PLANS FOR THE CONSTRUCTION OF
 PAVING, BRIDGE, STORM SEWER, WATER, SANITARY SEWER
 SIGNALIZATION AND STREETScape IMPROVEMENTS FOR

ARAPAHO ROAD - PHASE III

FROM SURVEYOR BOULEVARD TO ADDISON ROAD

PROJECT RECORD COPY I

Design	DAB	Drawn	DAB	DATE	SCALE	PROJECT NO.	SHEET NO.
Check	MP	Check	MP	2/4/05	VARIES	25768	LA-08

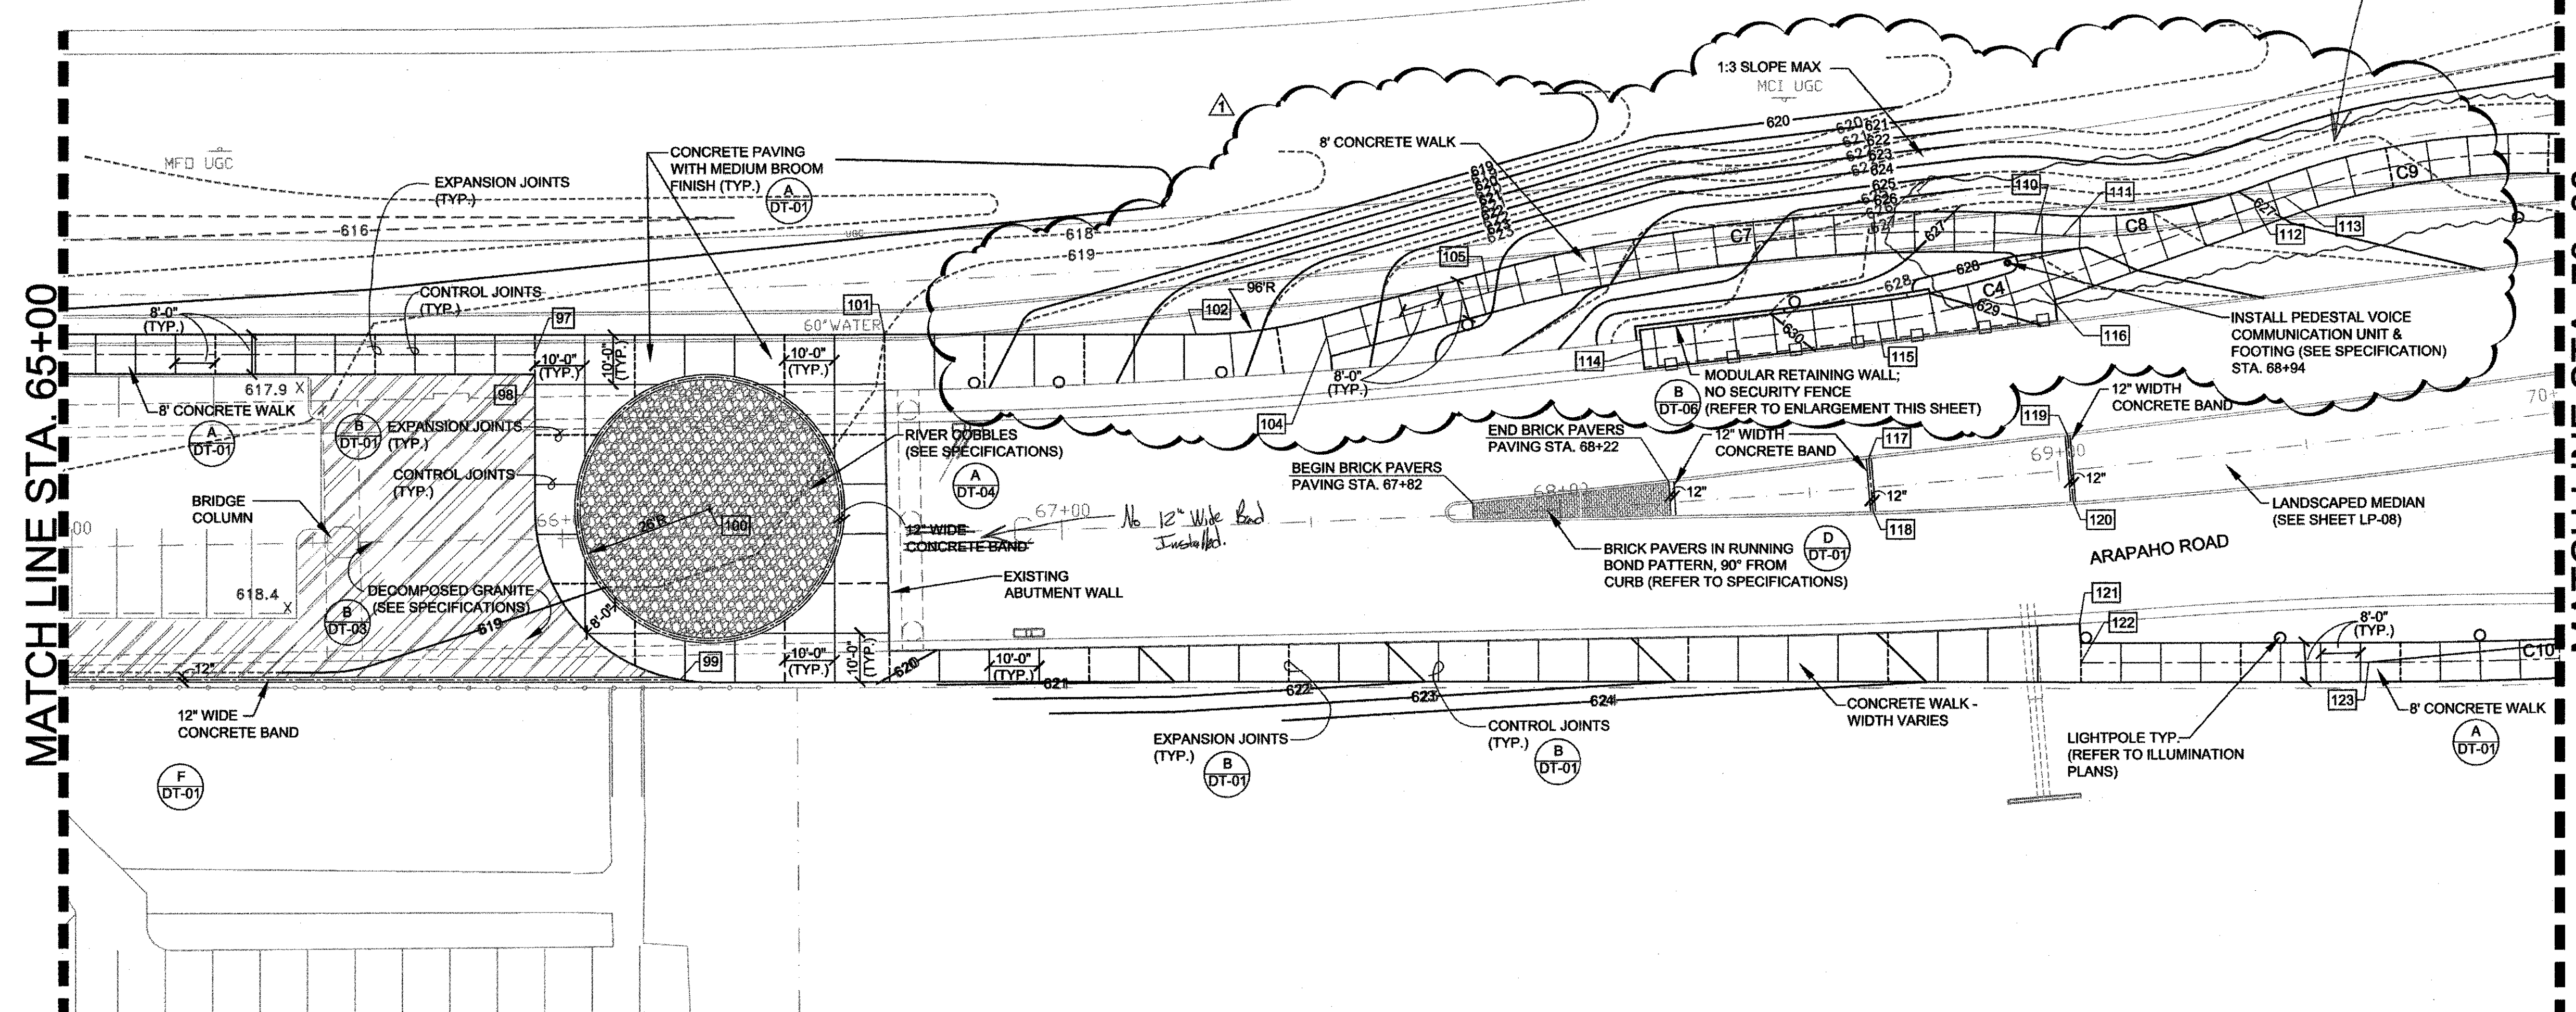
See RFI #088
North Sidewalk Grade Control between
STA 6850 and STA 8100.

Design	Drawn	DATE	SCALE	PROJECT NO.	SHEET NO.
DAB	DAB	2/4/05	VARIES	25768	LA-09

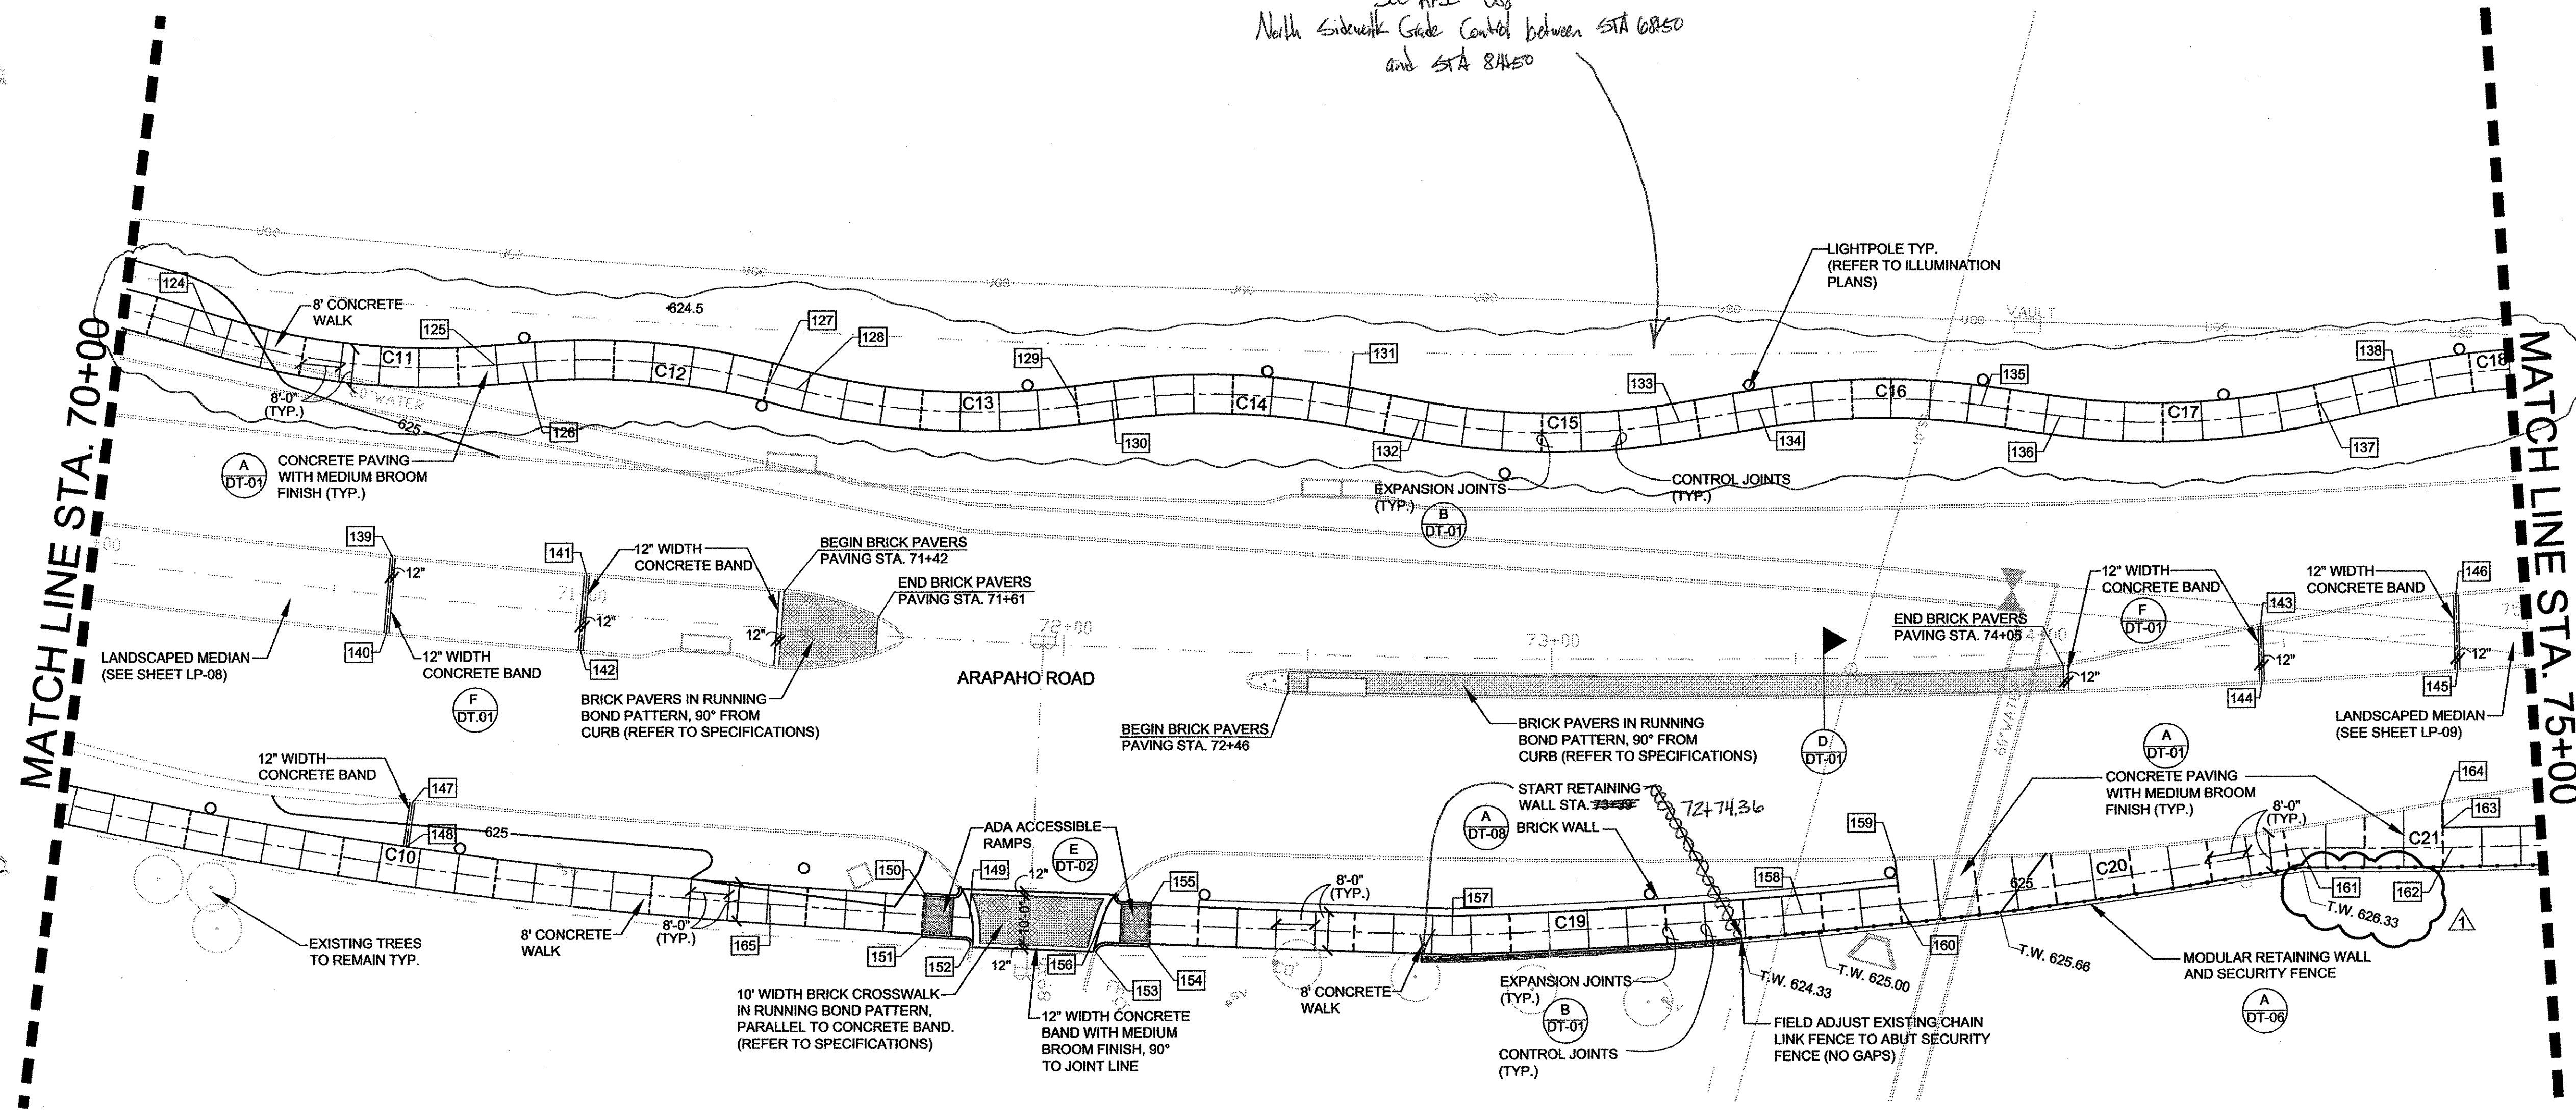
See REF # 088
North Sidewalk Grade Control between STA 6850
and STA 8450

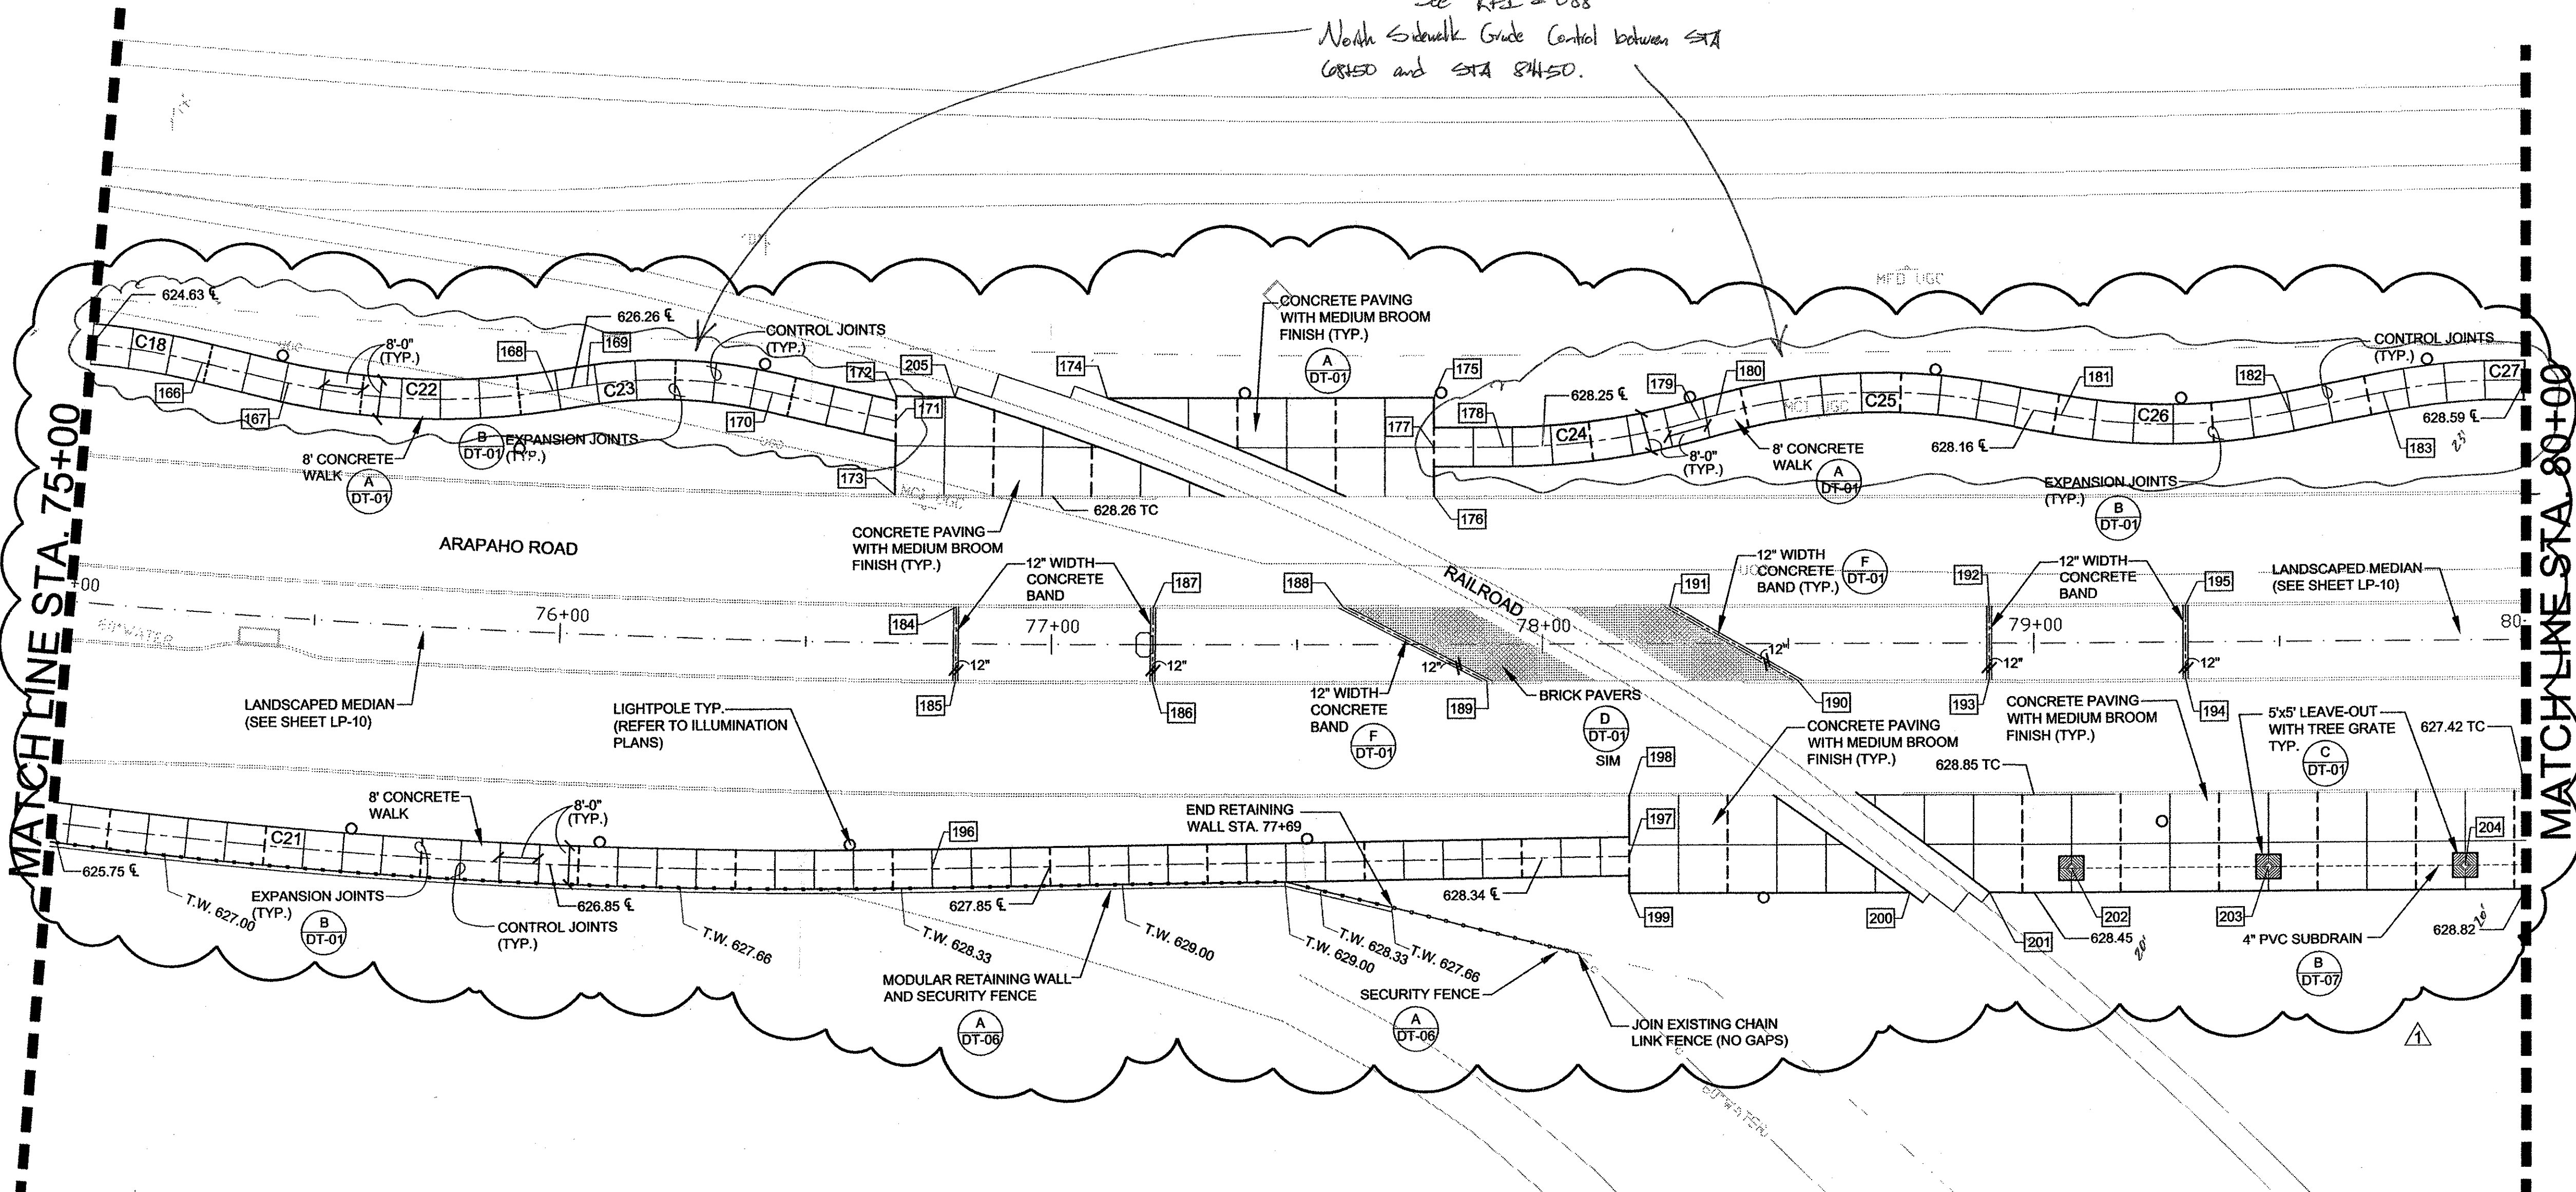
See REF #088
North Sidewalk Grade Control between STA 76+50 and STA 84+50.

Design	Drawn	DATE	SCALE	PROJECT NO.	SHEET NO.
DAB	DAB	2/4/05	VARIABLE	25768	LA-11

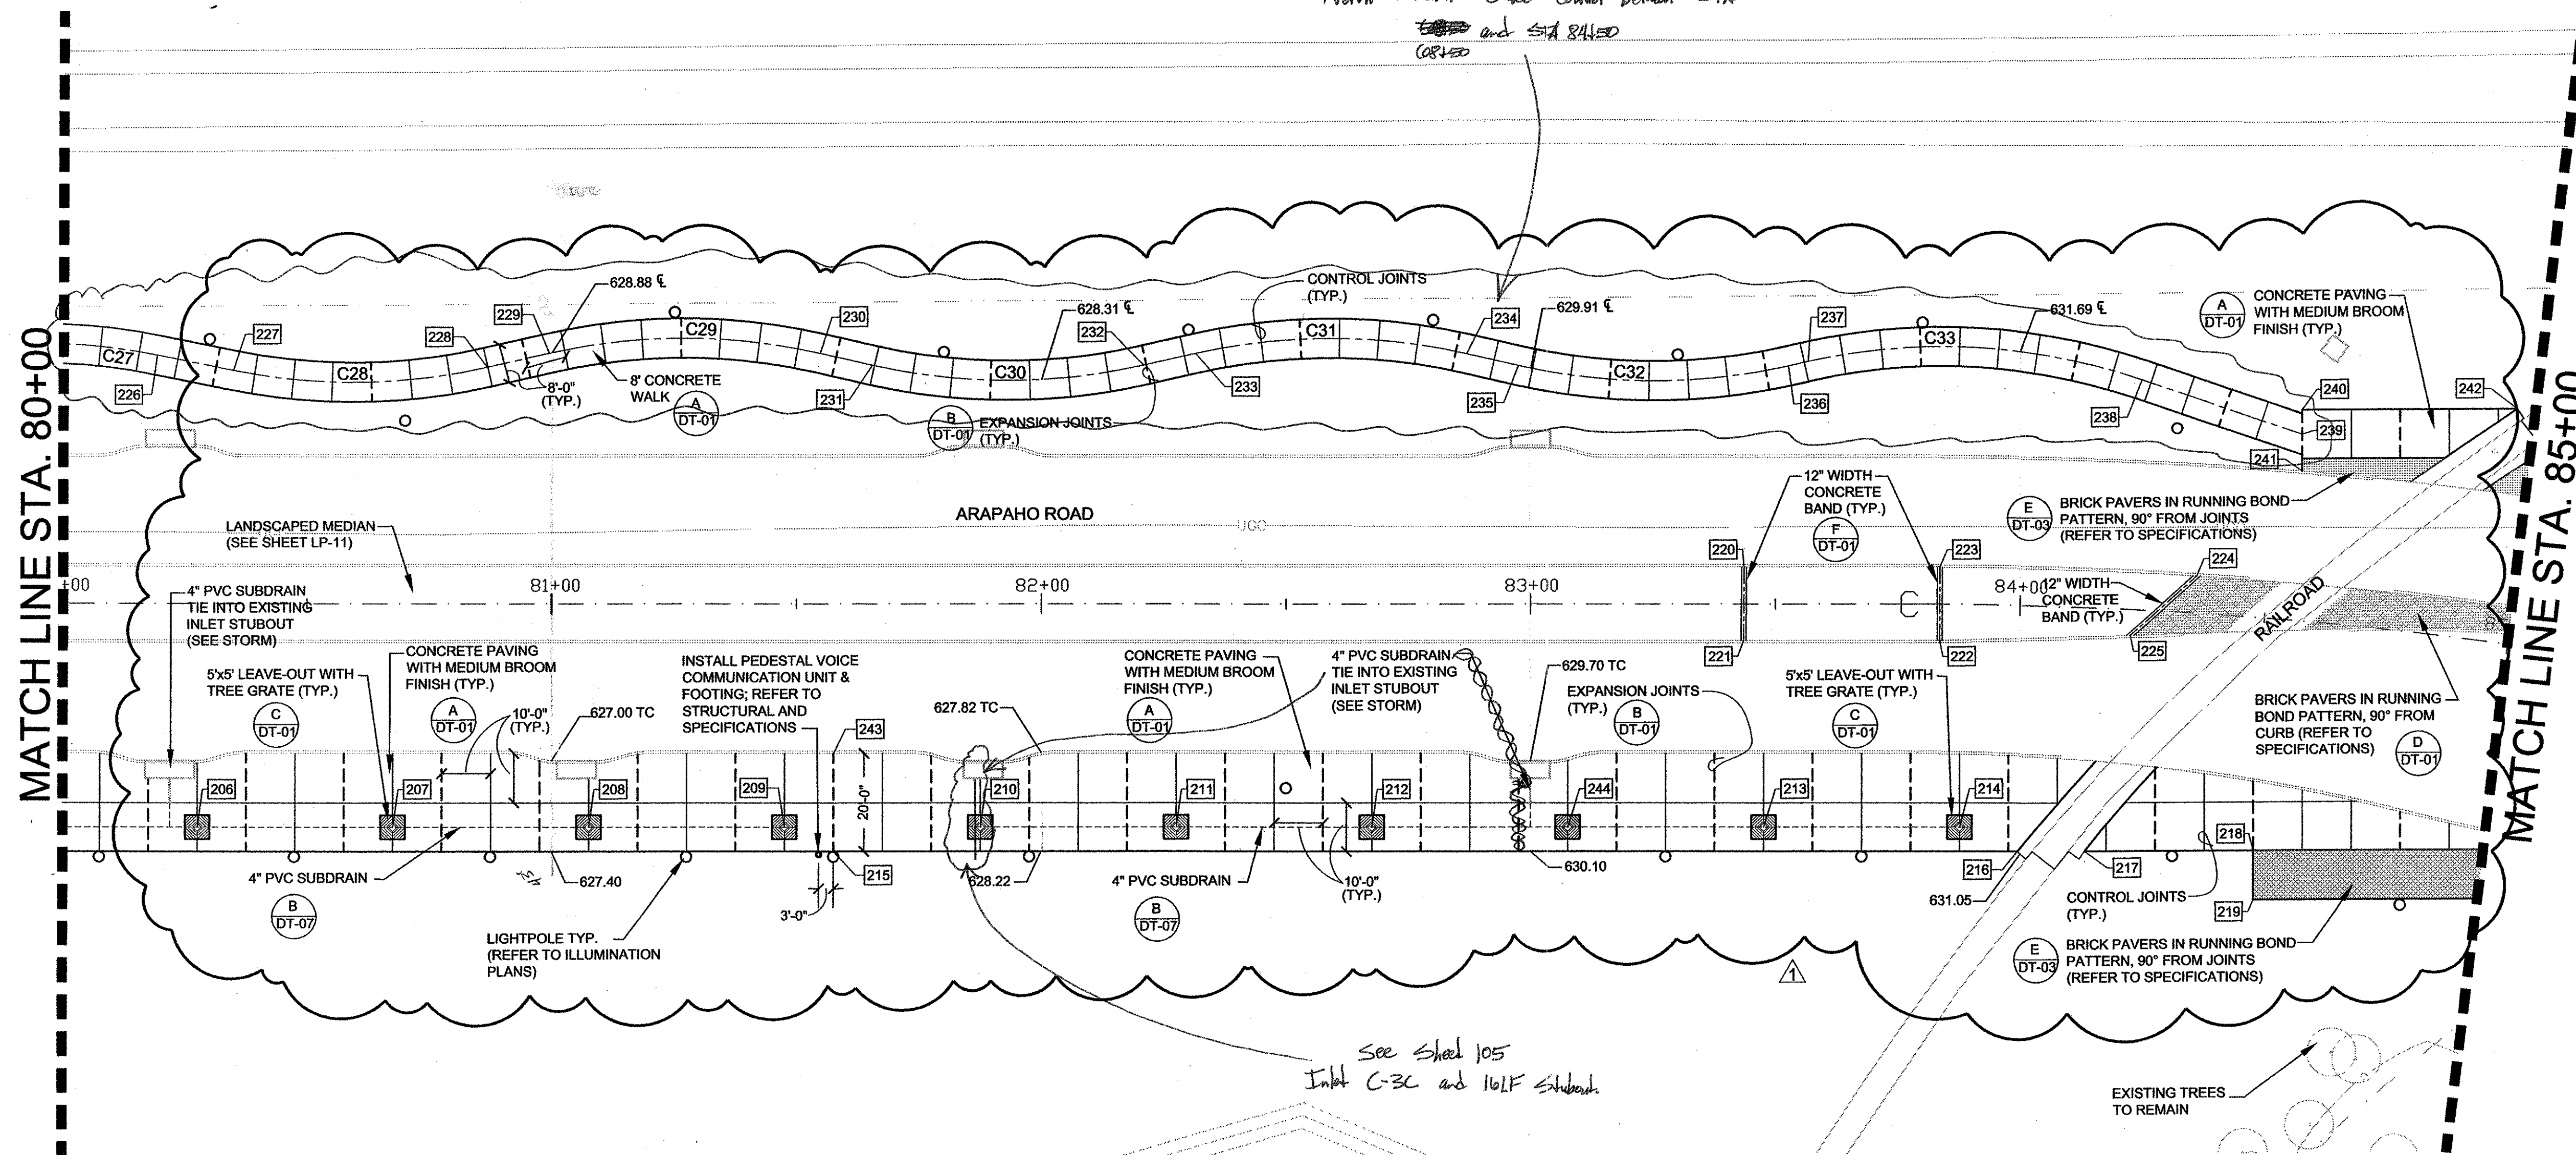
See RFI # 088
 North Sidewalk Grade Control between STA
 80+00 and STA 84+00
 CORDED

See Sheet 105
 Inlet C-30 and Half Subdrain
